Lindon City Planning Commission Staff Report

May 12, 2015

Item 4: Site Plan — Intermountain Precision Casting 1200 West 400 North

ARCHITECTURAL SITE PLAN
 SCALE: 1" = 10'-0"

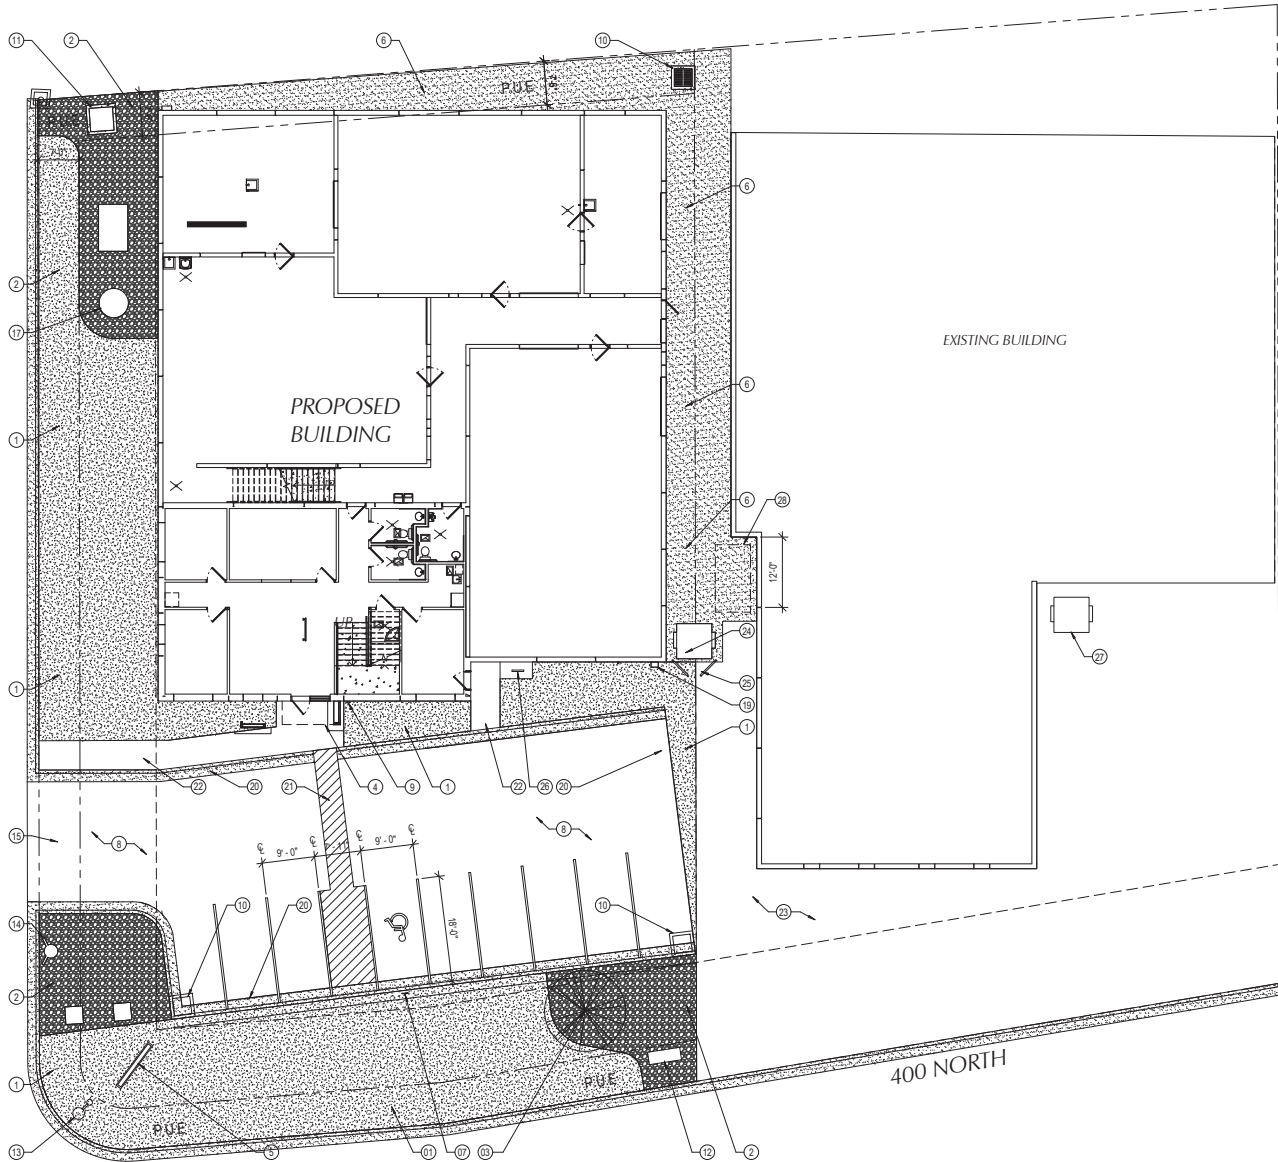
The Light Industrial zone requires a 20' landscaped strip along all street frontages with trees planted within the strip every 30' on center. Thirty percent of the frontage landscaping may be landscaped with non-living materials other than grass. The applicant is proposing grass and gravel in the parkstrip, with the gravel area taking up about 25% of the area; this is within code parameters. However, only one tree is being shown in the landscape strips. Three trees are required on the southern park strip (97 ft/30 ft) and 5 trees on the west parkstrip (139 ft/30 ft). Meeting this requirement should be a condition of approval.

The Code requires that interior landscaping must be provided for parking lots exceeding 10 stalls at 40 square feet per required stall and that at least 75% of the ground cover must consist of living vegetation. The site proposes 9 on-site parking stalls, which will require at least 360 square feet of interior landscaping, exclusive of the required landscaped strip along street frontage. This seems appropriate as 7 required stalls are being provided off-site. The submitted landscaping plan proposes 395 square feet of interior grass turf landscaping. The landscaping plan complies with the intent of the interior landscaping requirement.

SITE PLAN
1" = 20'-0" (A5)

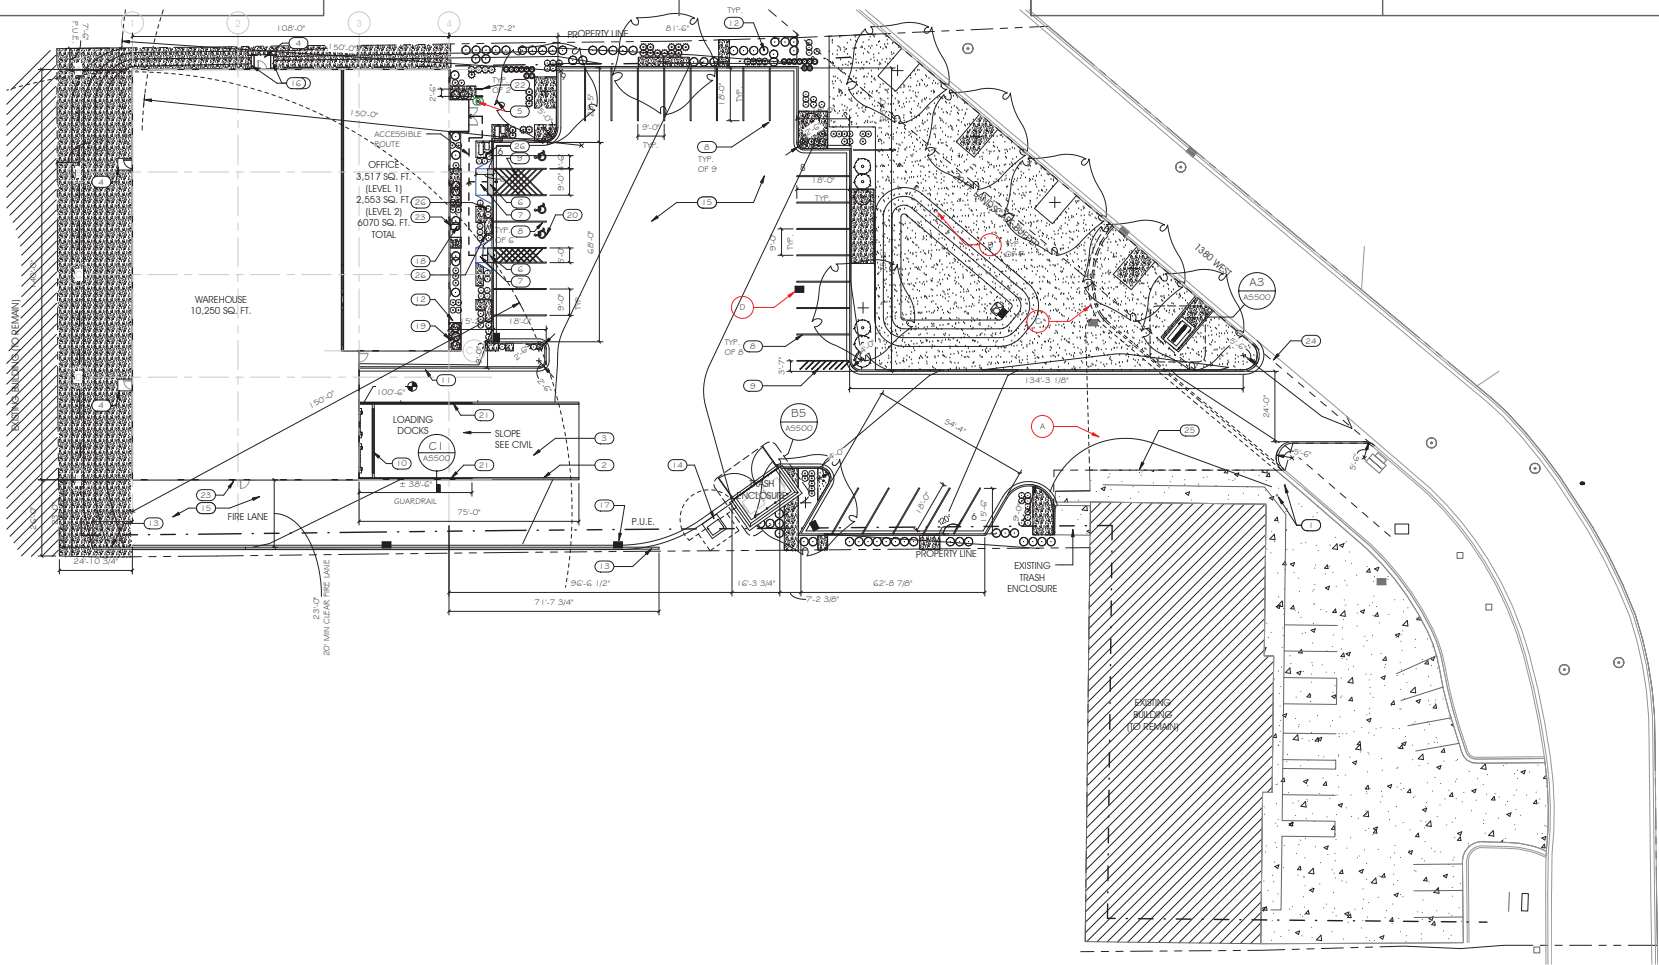
Additionally, the Code requires 2 bicycle parking stalls. The site plan proposes a bicycle rack with 2 slots to meet this requirement.

The Light Industrial zone requires a 20' landscaped strip along all street frontages with trees planted within the strip every 30' on center. Thirty percent of the frontage landscaping may be landscaped with non-living materials other than grass. The proposed site plan satisfies these requirements.

LANDSCAPE PLAN

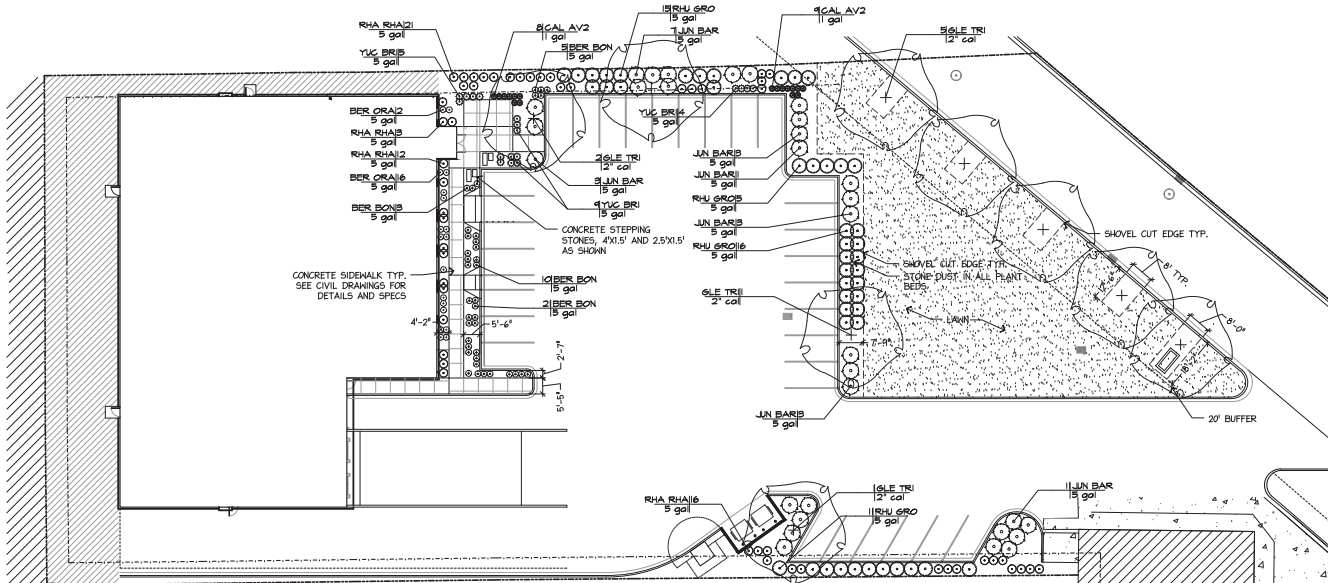
The Code requires that interior landscaping must be provided at 40 square feet per required stall and that at least 75% of the ground cover must consist of living vegetation. The site proposes 29 parking stalls, which will require at least 1,160 square feet of interior landscaping, exclusive of the required landscaped strip along street frontage. The submitted landscaping plan proposes 3,112 square feet of interior landscaping with 2,580 square feet of living vegetation, which healthily exceeds the minimum square footage requirement and meets the 75% living vegetation requirement for interior landscaping.

The code also requires 1 interior tree per 10 required parking stalls. The proposed site plan includes 4 interior trees to satisfy this requirement.
